First Hill Booster Pump Station Generator Replacement  
PROJECT NUMBER: 25-55

**ADDENDUM NO. 1**

ISSUED THIS DATE: January 13, 2026

WALL & SLAB SECTION  
B 55

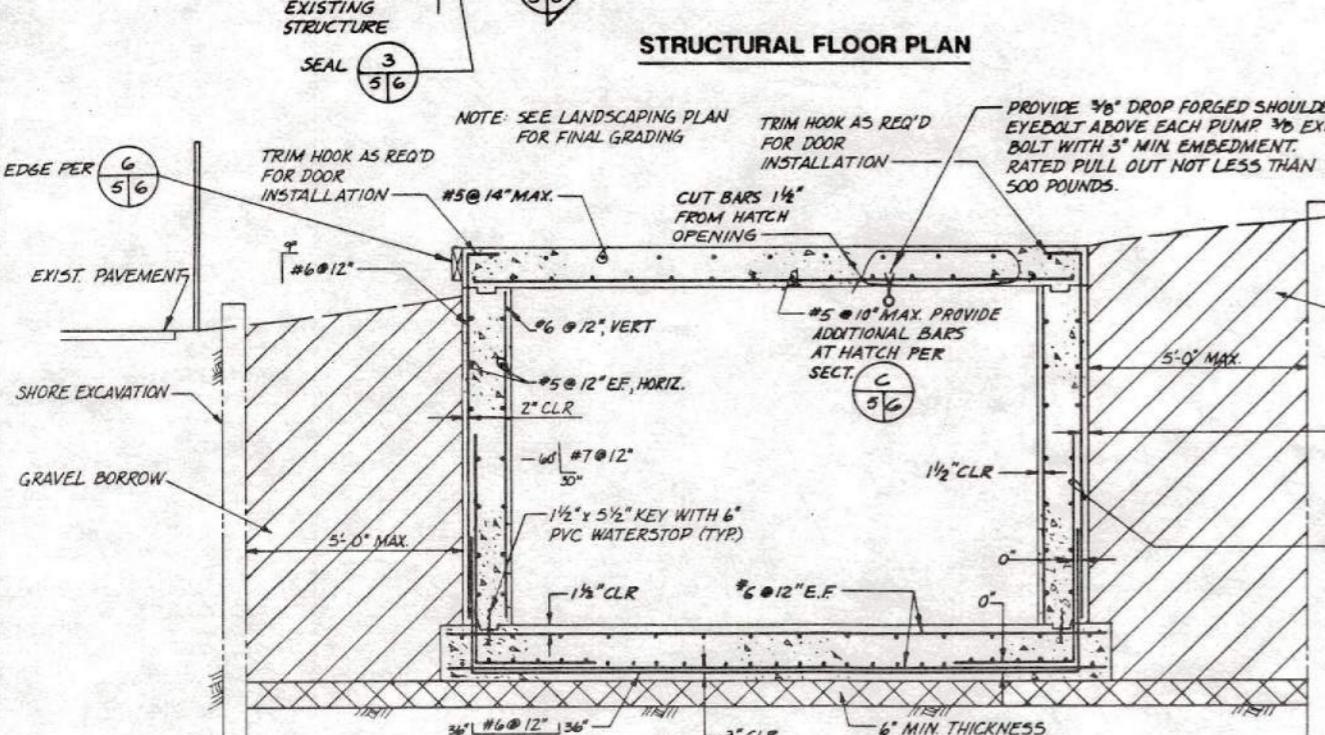
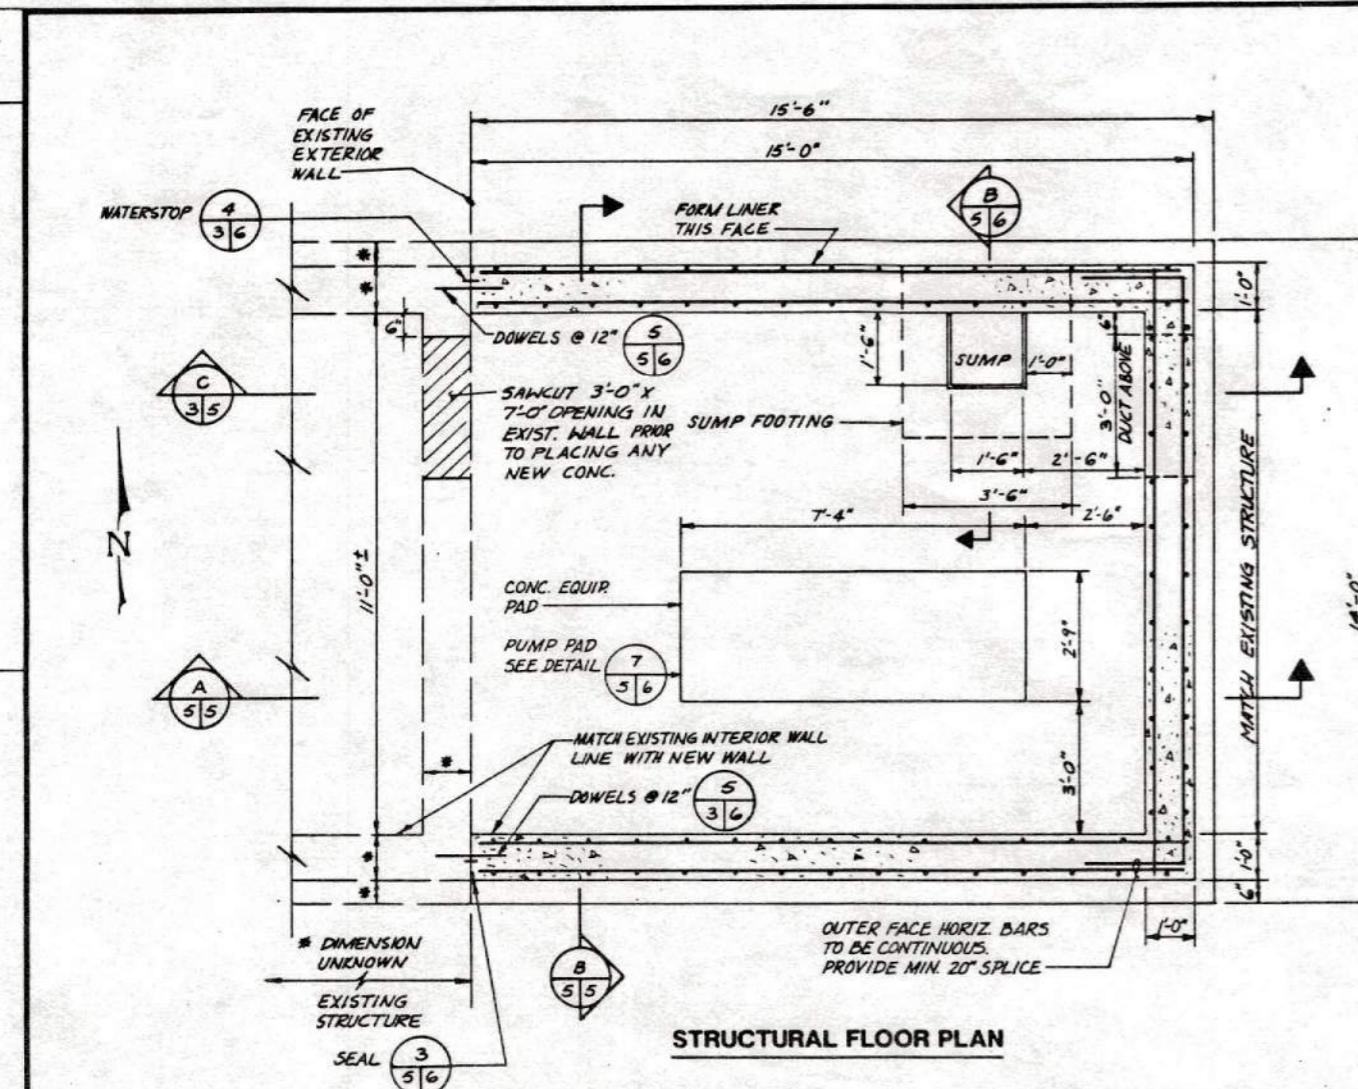
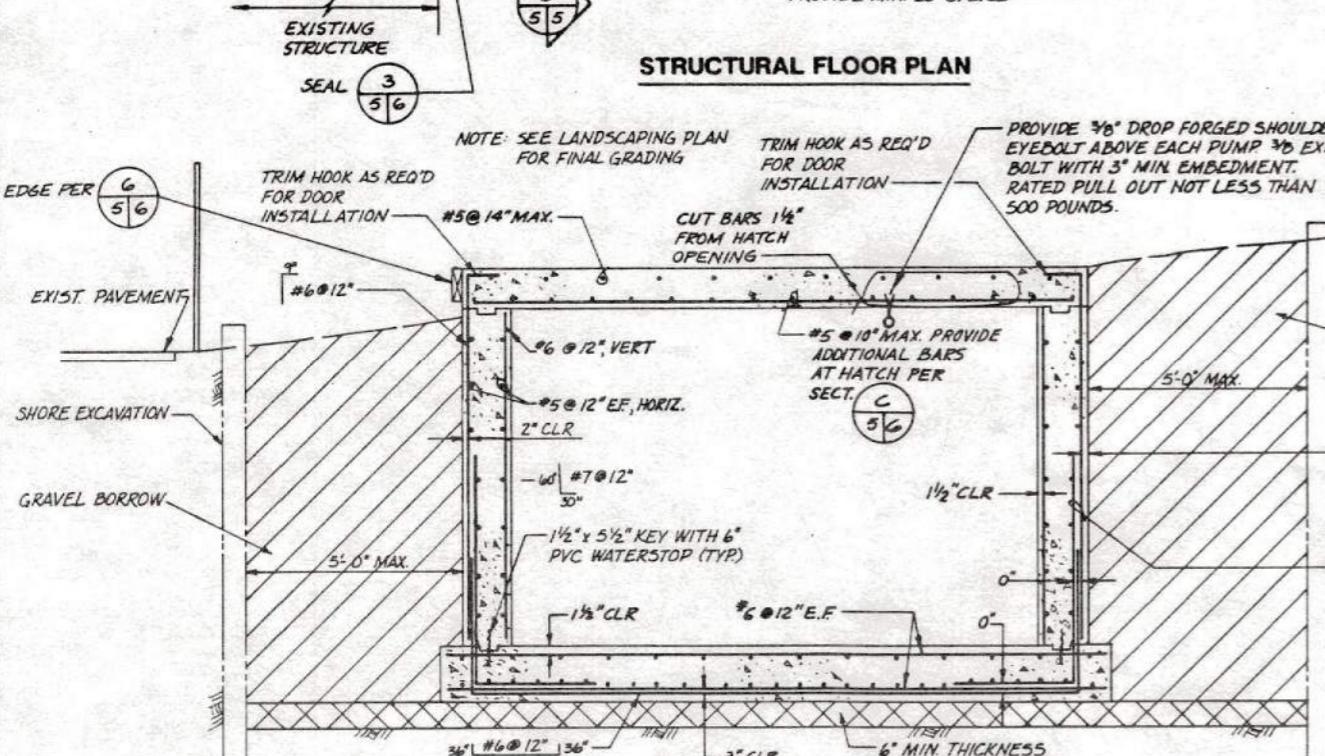
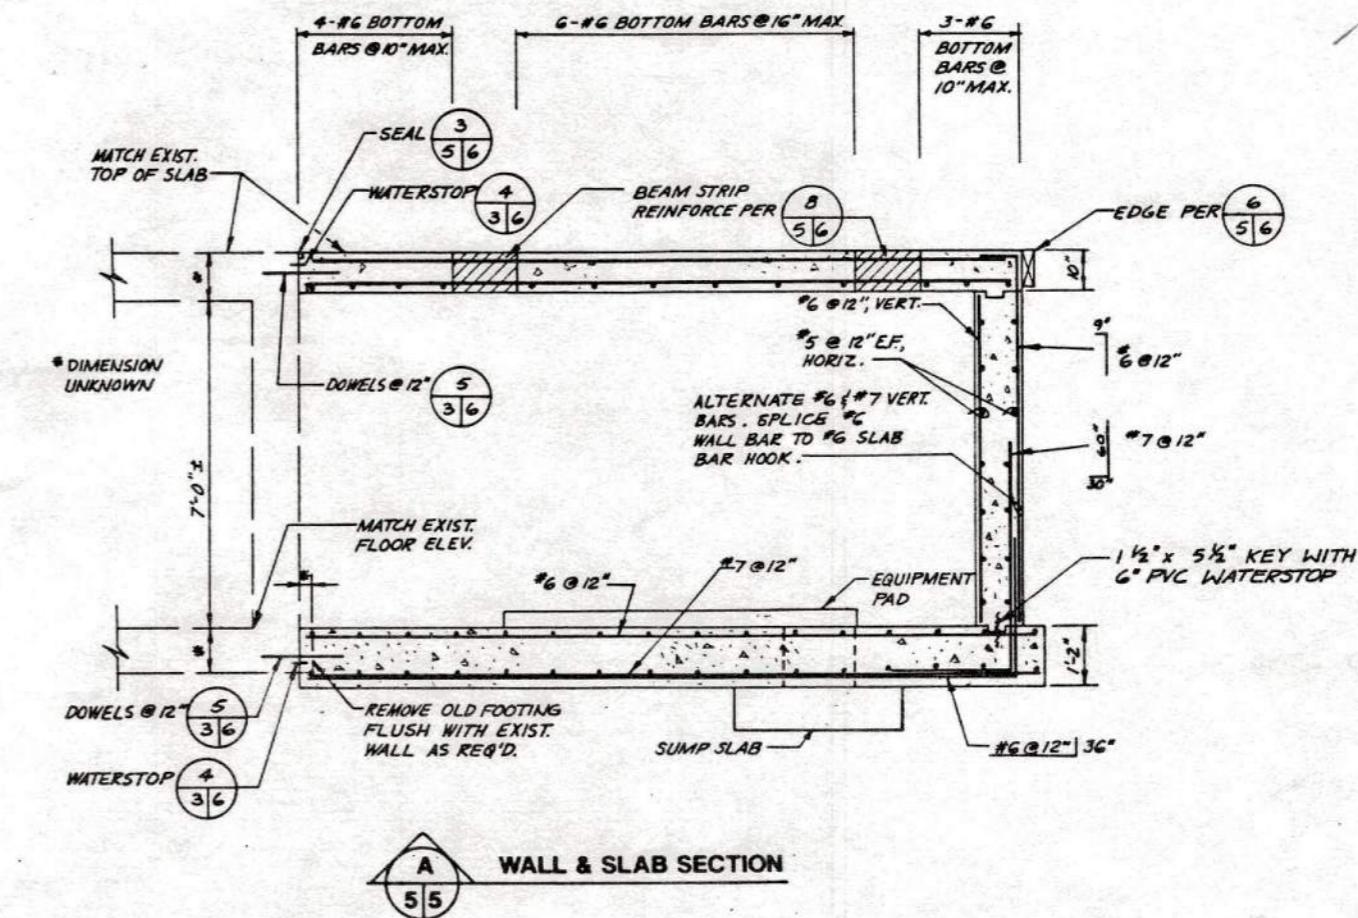
**Q3:** Are original structural drawings showing the existing vault available?

**A3:** The as-built 1990 structural sheets are being provided as part of this addendum. The generator is actually located in the pre-1990's vault section. Unfortunately, there are no drawings available for this section.
